# Access Compliance Report

## Public Rights-of-Way

Intersection ID: 7027	Main Street: TALUS_TRACE_LN	Cross Street: BEGONIA_DR	Location:	E
ADA ID: 3C1A6F949AEF	Ramp Type: PerpDiag	Initial Pass/Fail: Fail	Overall Compliance: No	Severity Score: 8.75
Codes/Mitigation Info/Possible Solution		Field Measurements/Component Compliance

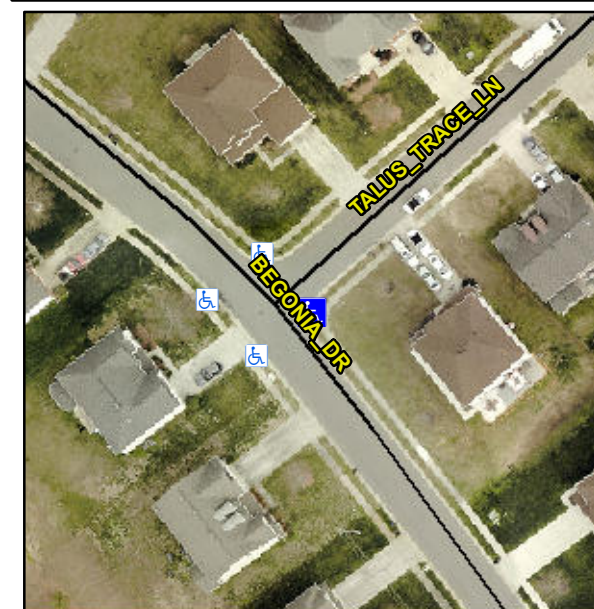
**Not Found, R304.5.1**

Compliance	Description	Data	Compliance	Description	Data
N/A	Ramp Length (in)	49.0	Yes	Ramp Slope (%)	6.1
No	Ramp Width (in)	47.0	Yes	Ramp XSlope (%)	1.2
N/A	Flare Type LT	N/A	N/A	Flare Type RT	N/A
N/A	Flare Slope LT (%)	N/A	N/A	Flare Slope RT (%)	N/A
N/A	Flare Traversable LT?	N/A	N/A	Flare Traversable RT?	N/A
N/A	Landing Length (in)	N/A	N/A	DWS Provided?	N/A
N/A	Landing Width (in)	N/A	N/A	DWS Contrast?	N/A
N/A	Landing Slope (%)	N/A	N/A	DWS Length (in)	N/A
N/A	Landing X Slope (%)	N/A	N/A	DWS Full Width?	N/A
N/A	Landing Curb? (Y/N)	N/A	N/A	DWS Offset (in)	N/A
N/A	Shared Landing?	N/A			
N/A	Gutter Ponding?	N/A	N/A	Gutter Slope (%)	N/A
N/A	Gutter Lip Ht (in)	N/A	N/A	Gutter X Slope (%)	N/A
N/A	Painted X Walk1?	No	N/A	Painted X Walk2?	No
	X Walk 1 Direction	To NW		X Walk 2 Direction	To SW
N/A	X Walk 1 Width (in)	N/A	N/A	X Walk 2 Width (in)	N/A
	X Walk 1 Slope (%)	2.9		X Walk 2 Slope (%)	2.4
	X Walk 1 X Slope (%)	3.0		X Walk 2 X Slope (%)	2.7

**Remove & Replace Curb Ramp With Two New Directional Ramps or Equivalent.**
